I am writing on behalf of my constituent, Ms Ursula Dewar of SP65120 at 2/9 Nelson Street, Chatswood, regarding her concerns with the Chatswood Metro dive site layout Environmental Impact Statement (EIS).

Re: Sydney Metro EIS submissions & recommendations due June 27th

Figure 7-8 Chatswood dive site (northern) indicative layout

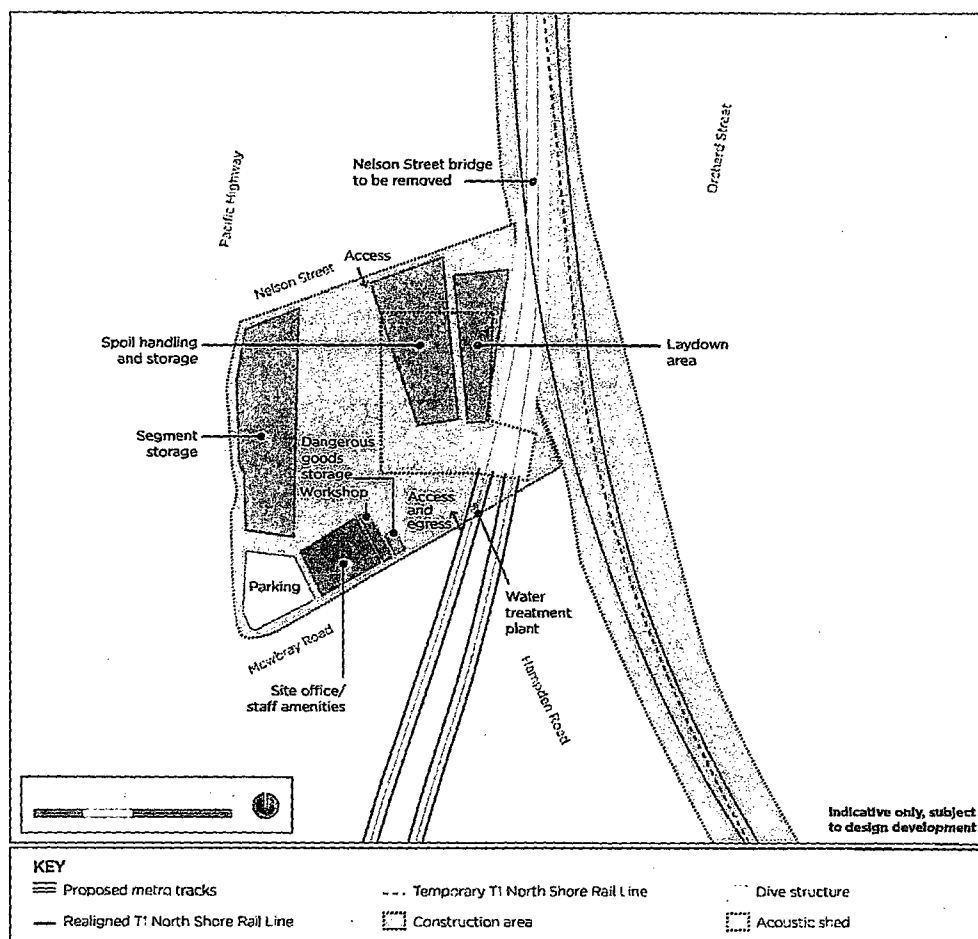
*Tracks will be moved west by 3m @ Gordon Ave/Nelson St: closer to our Strata. Metro considers moving northbound T1 track west by 3m to be necessary because excavation for Metro (between 2 North Shore tracks) will start at the Bowling Club & continue to the Ausgrid site opposite my residence at 9 Nelson Street.

- *Whether the drilling of extra piles & retaining walls between Nelson St & Gordon Ave will de-stabilise our foundations. Drilling will be very noisy for long periods and its vibrations harmful: causing cracks in our building.
- *Whether the extra piles & retaining walls will safeguard our Strata's foundations, since the retaining walls will be only about 8m from our Strata (EIS Ch.7, p208).
- *Rail-corridor will be widened near Nelson Street (although the Frank Channon Walkway will be retained between my residence & the rail-corridor.)

SOLUTION: to build Metro dive elsewhere & not at Ausgrid site opposite 9 Nelson Street.

Figure 7-7 Northern surface track works

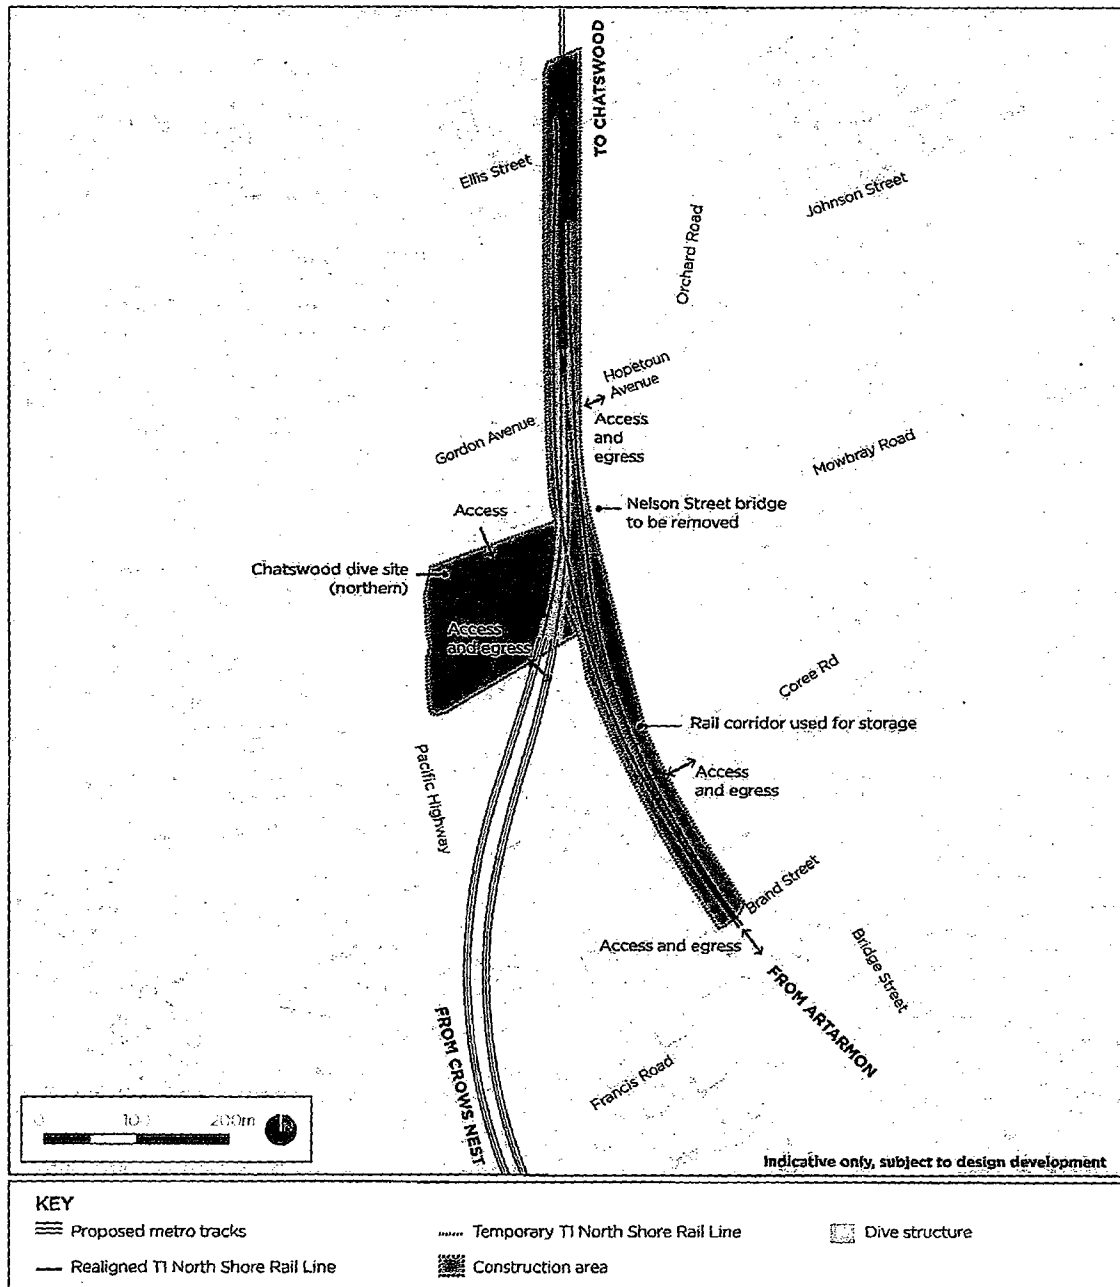
5/ ISSUE: cross-over of Metro & North Shore Northbound T1 tracks are at wrong place.

- *The cross-over is at the wrong place.
- *Metro tracks should not be separated by the two North Shore tracks.
- *The Chatswood Metro dive site is short-sighted: this should have been evaluated during the planning and implementation of the ECRL 2003-2007.³
- *You don't have the space that's available for the Metro Northwest to Rouse Hill.
- *See attachments.

- *The Metro reps last Saturday said: 1.5m trains will be visible above "noise wall". The maximum height of the proposed rail-bridge (for northbound track T1) will be at Nelson Street, with 100-300 meters long grade either side.
- *Please see attachment.
- *The North Shore T1 northbound track is located adjacent to the Frank Channon Walkway, and is proposed to be located only 8m from no.1 Gordon Avenue (strata opposite our block). Before the ECRL was completed in 2007, T1 was located 14m from no.1 Gordon Avenue.
- *Height of our "noise wall" will be increased: obstructs sea-breeze from the east/coast.
- *It's taken years for vegetation to grow up the "noise wall".

SOLUTION: to separate Metro & North Shore tracks at/near Chatswood train interchange or elsewhere, and not build cross-over at Nelson Street/ Gordon Avenue, adjoining Ausgrid site: avoiding the permanent removal of Nelson Street Bridge.

- *Rail-bridge should not be built over Nelson St, and both Metro tracks should be located together from Albert Avenue rather than in between the 2 North Shore Line tracks.
- *Nelson Street Bridge should not be permanently closed.
- *To build Metro dive elsewhere and not at Ausgrid site opposite 9 Nelson Street.

Demolition
of the Nelson
Street bridge

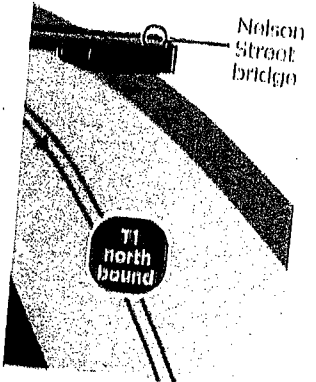
Due to EIS proposal for Nelson St Bridge to be closed permanently.

Decommissioning of Nelson St Bridge will have an impact on our residents that has been understated by Metro.

- *Nelson Street Bridge should be retained: not demolished permanently.
- *Signalization (traffic lights) at junction of Nelson St & Pacific Hwy. Otherwise, residents/tradesmen travelling north along Pacific Hwy would need to travel a circular loop through Chatswood CBD (Albert Ave), along narrow congested Orchard Road, to get to Nelson Street: no right-hand turns along Albert Avenue past Orchard Road.
